Riverbend Water Resources District
Phase 3 Report on Water Treatment Plant and Raw
Water Intake Site Selection

Submitted To Riverbend Water Resources District

CH2M HILL
and
MTG Engineers and Surveyors

August 29, 2012

FIGURE ES-02
LAKE WRIGHT PATMAN
RECOMMENDED INTAKE LOCATION

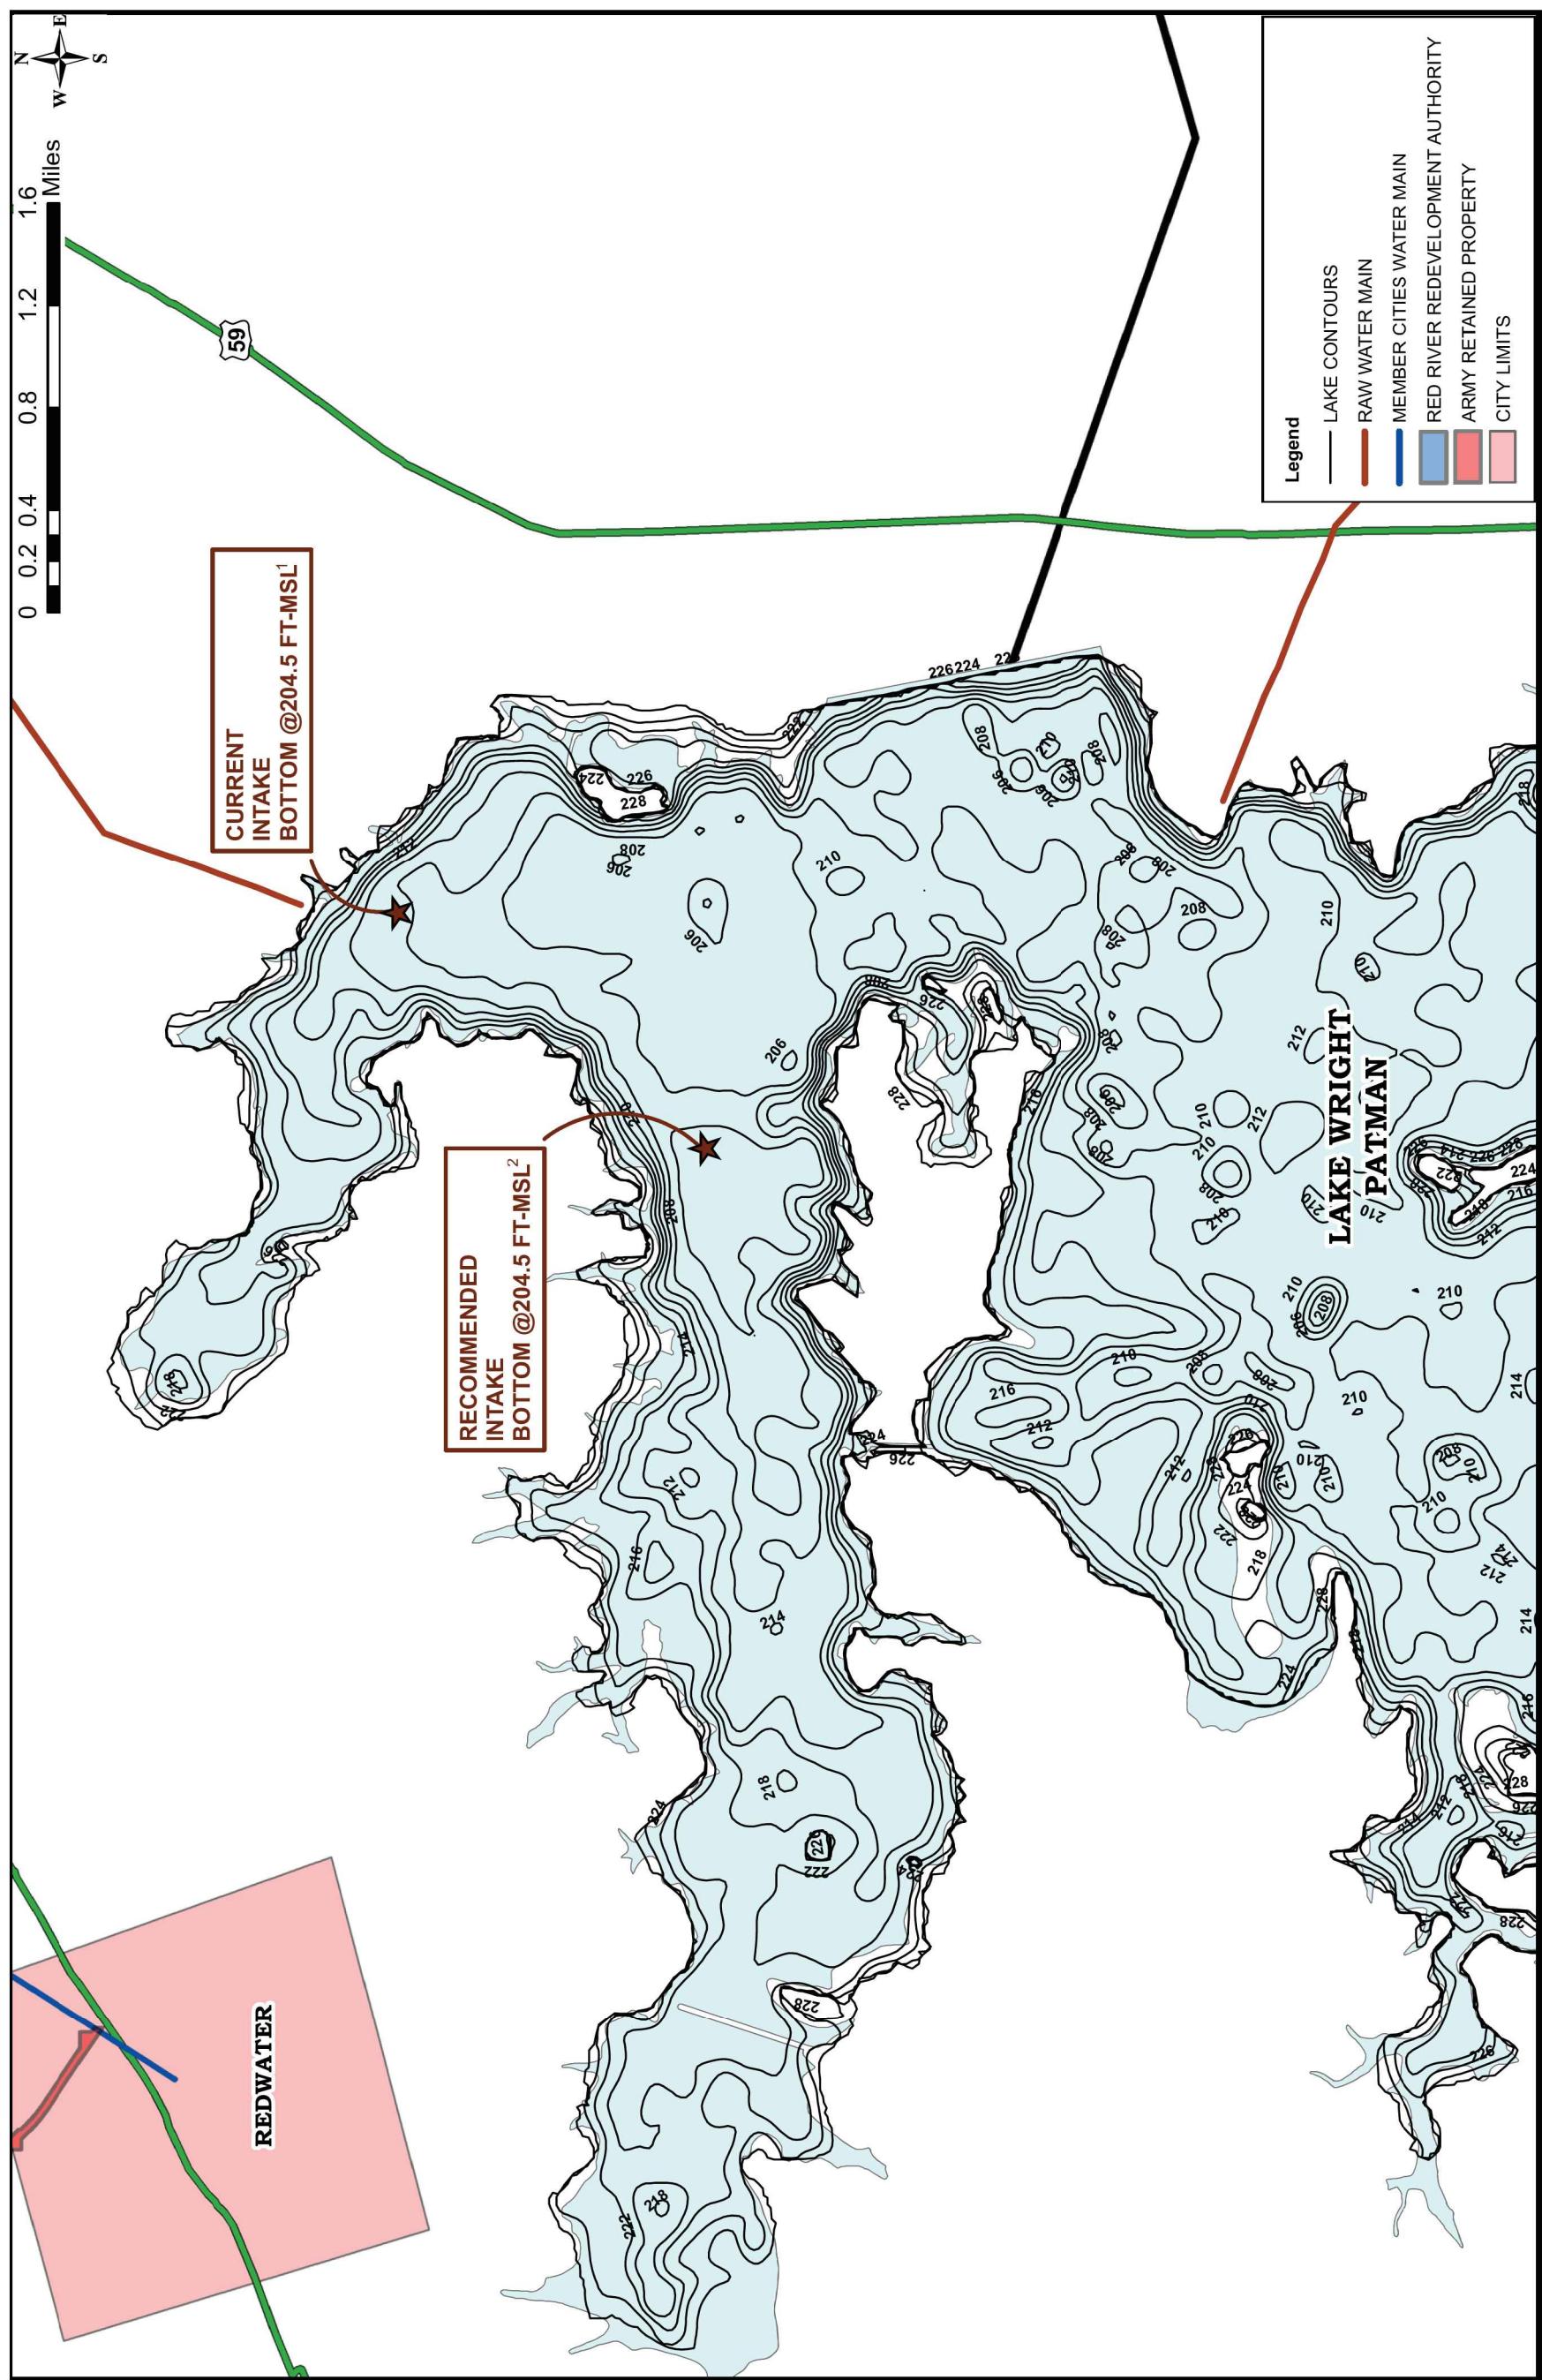
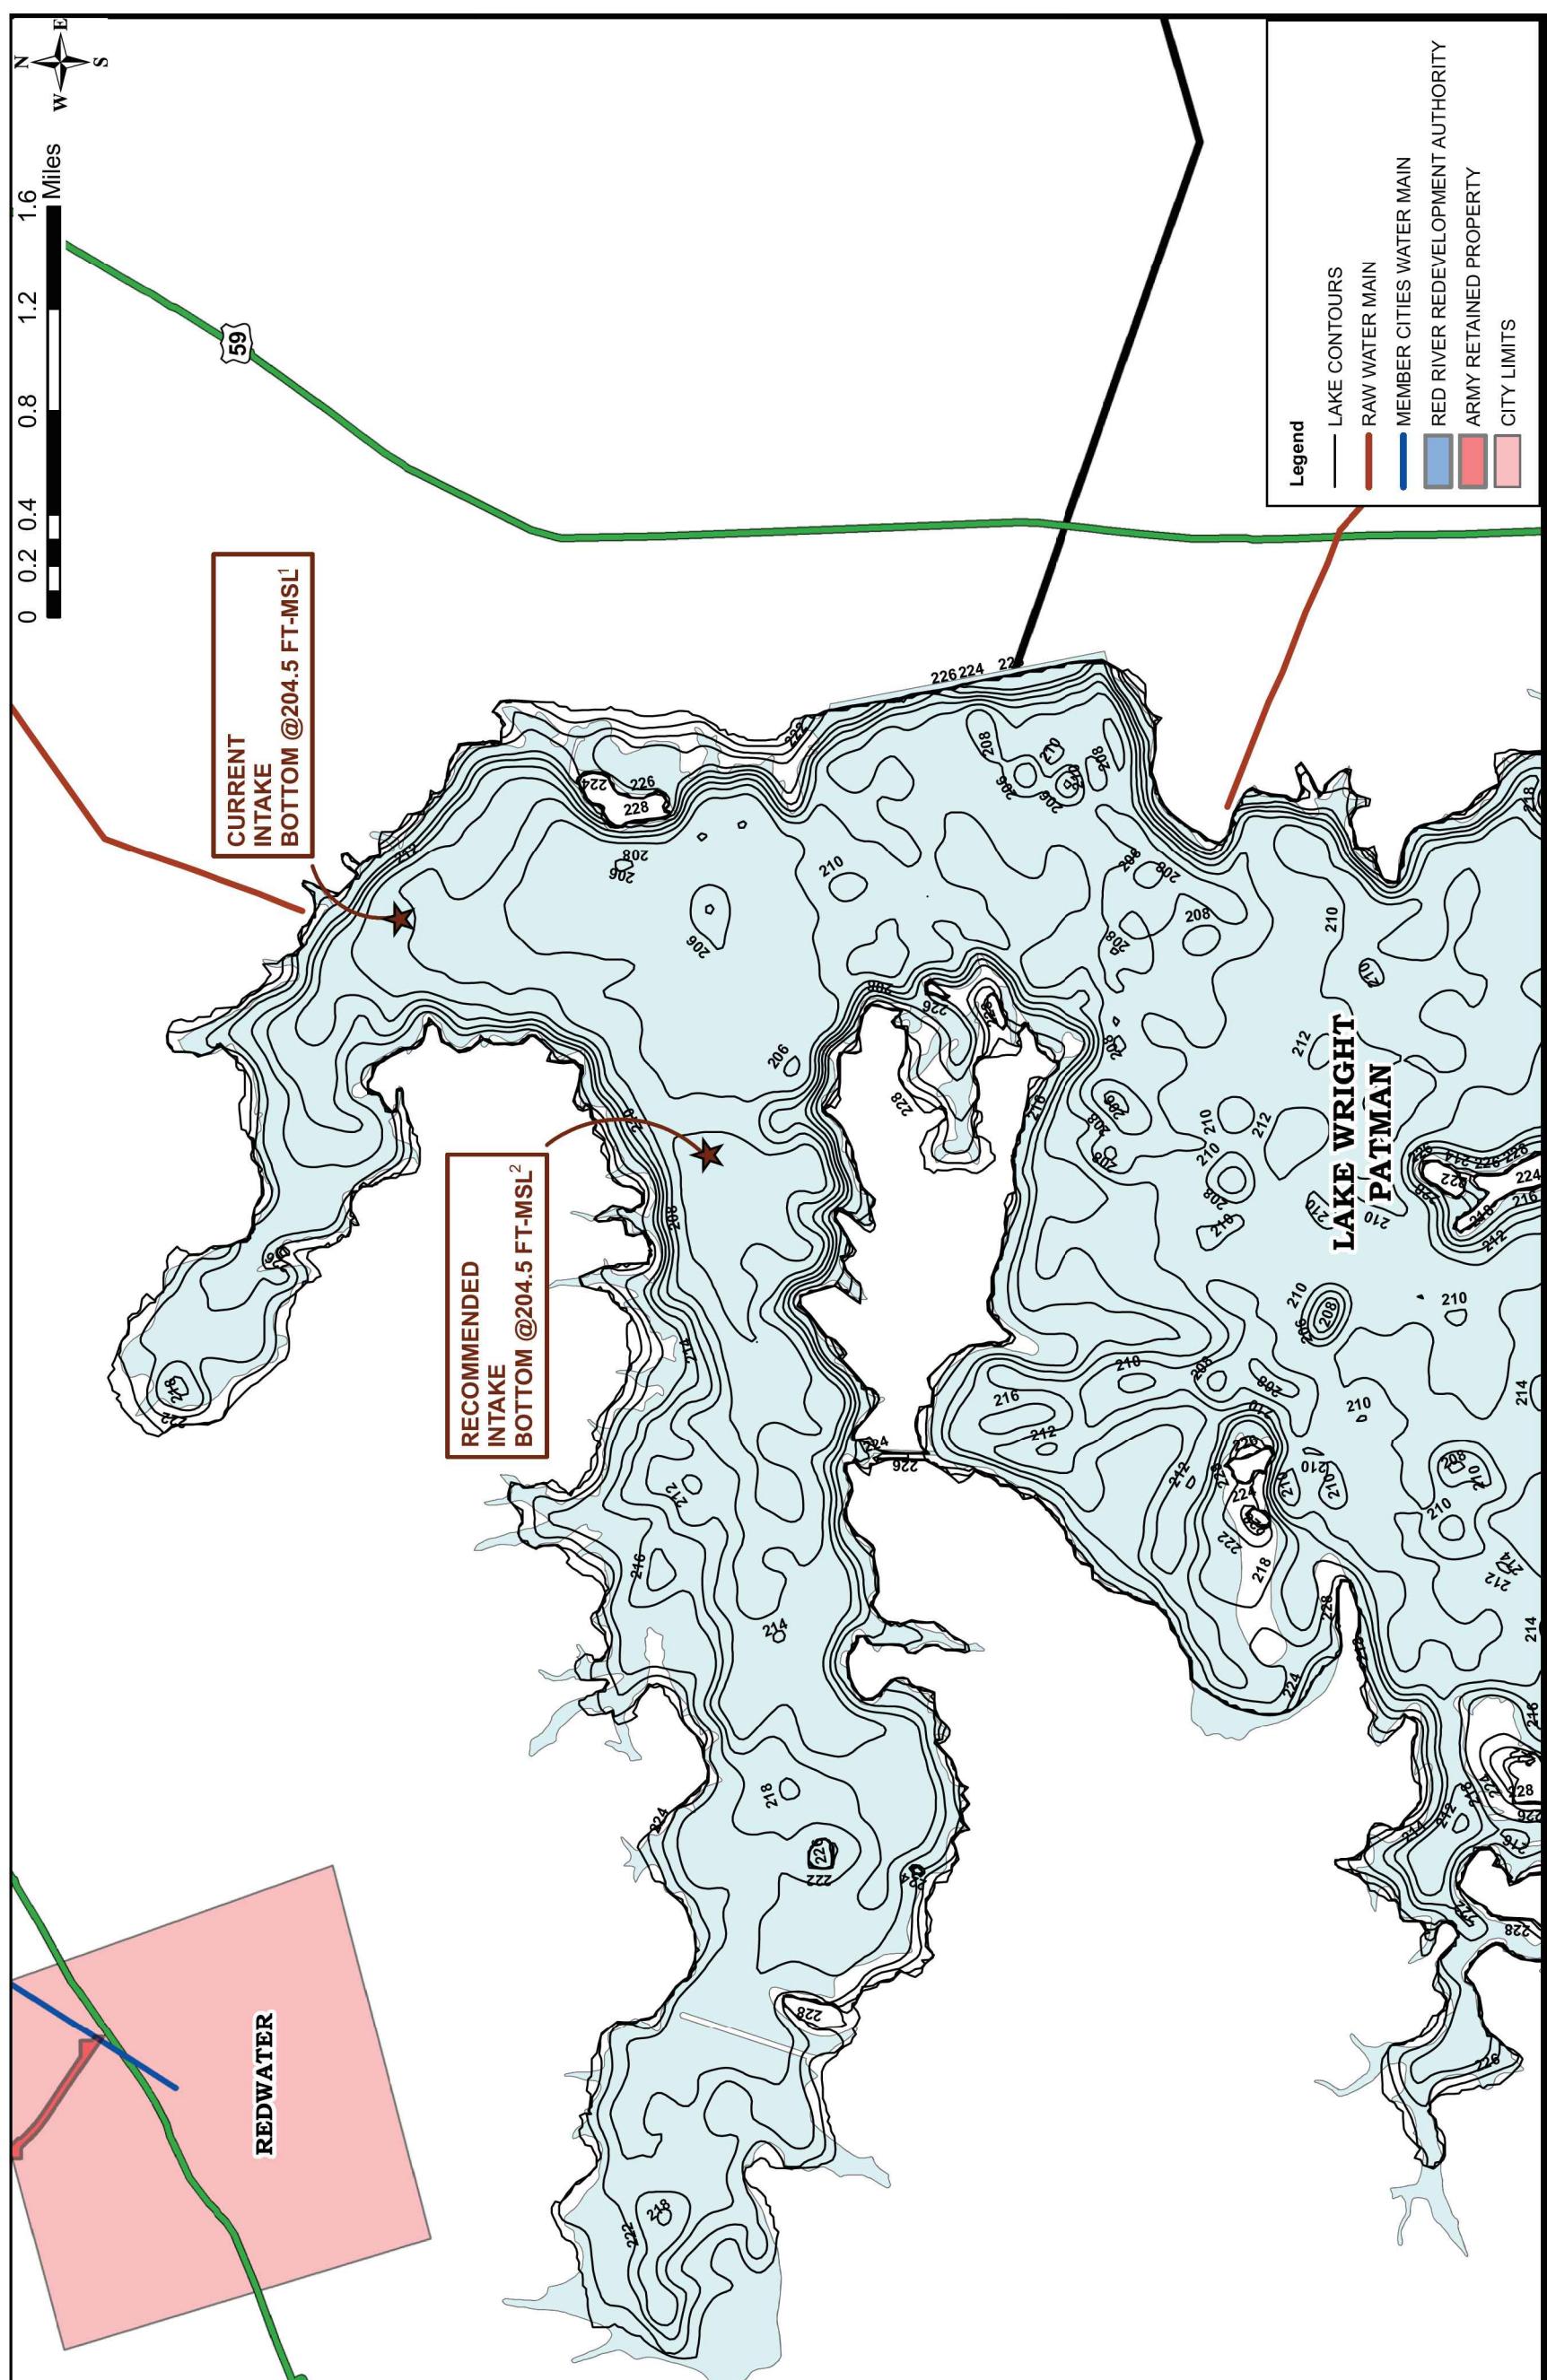
3. Please list the members or customers of the district that potentially will be served by any new regional facilities in the executive summary or in chapter one of the report.
4. Figure ES-02 and Figure 5-01: There are both stars and green dots indicating intake locations. Please provide more detail in the map legend differentiating these locations to prevent confusion.
5. Figure ES-03 & Figure 6-01: The pipeline infrastructure required for each alternative is not differentiated. Suggest coding pipeline routes for each alternative to prevent confusion.
6. Since this is the third phase of a 3-phase study, please summarize the first two phases in the executive summary or reference the location in the main report of this discussion.

FIGURE 2-03

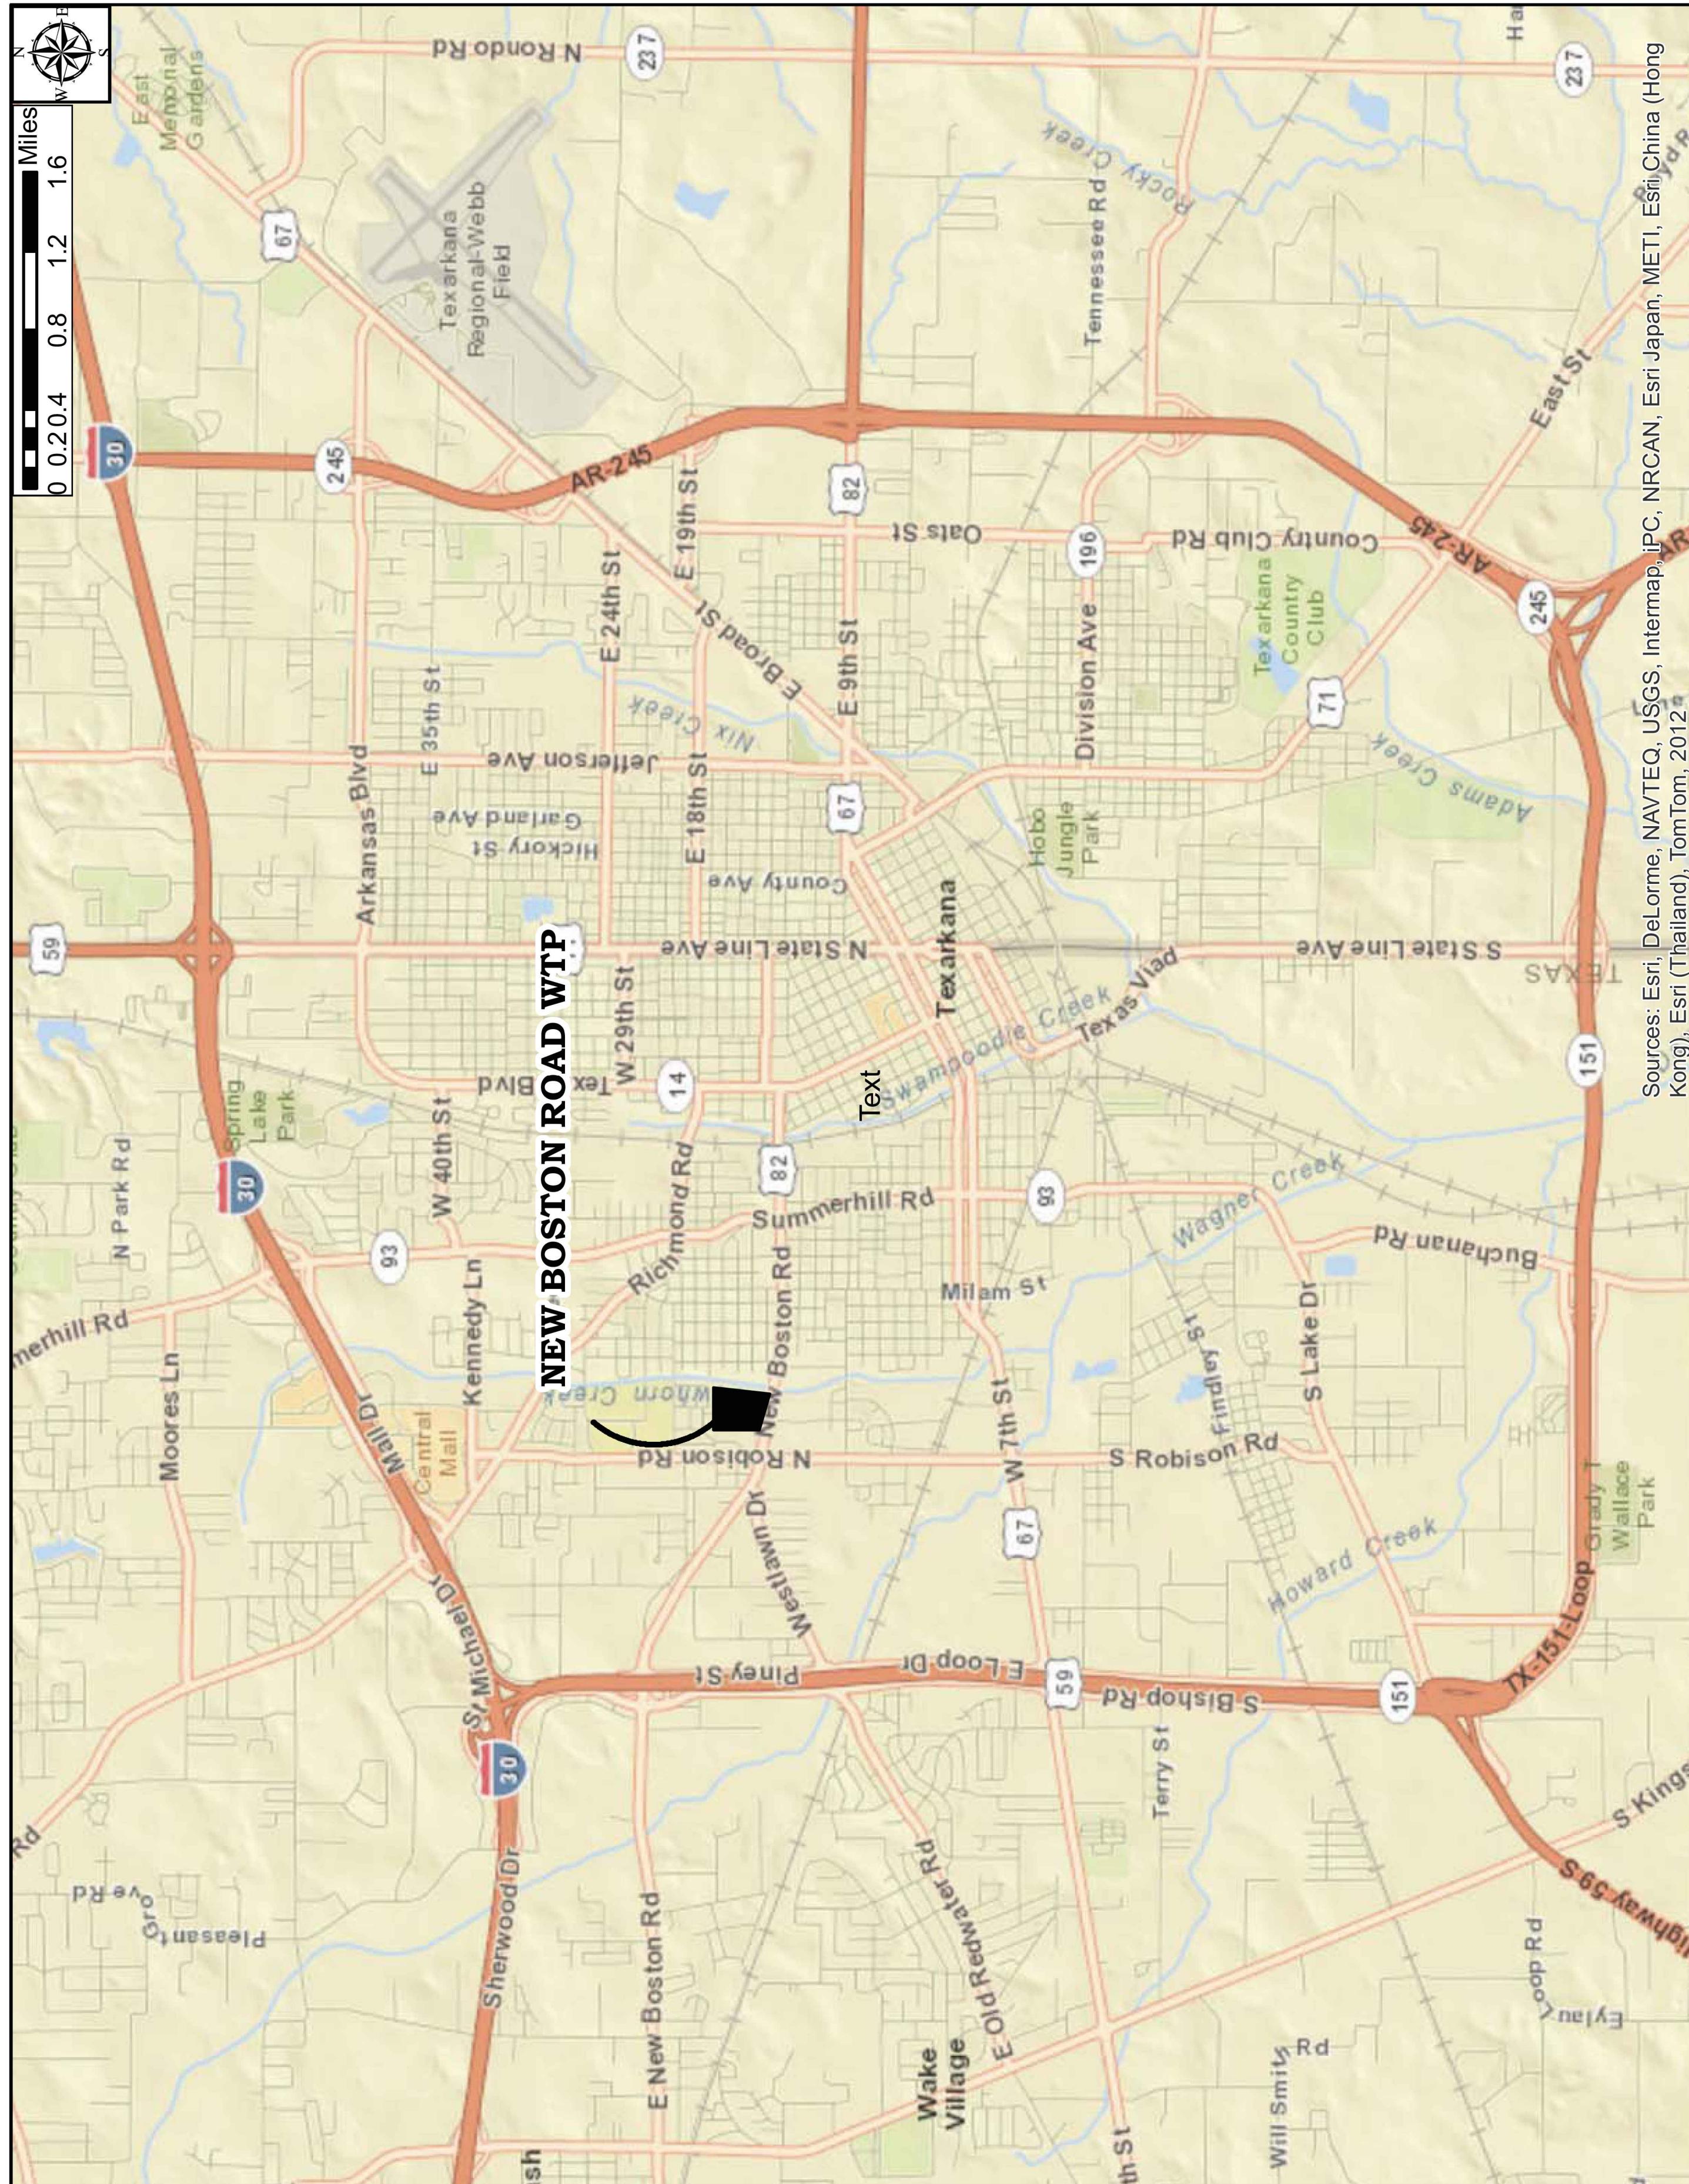
4. Suggest adding subsection numbers to subtitles to aid the reader in navigating the report.
5. Figure 2-03: Suggest adding North arrow and scale to map figure.
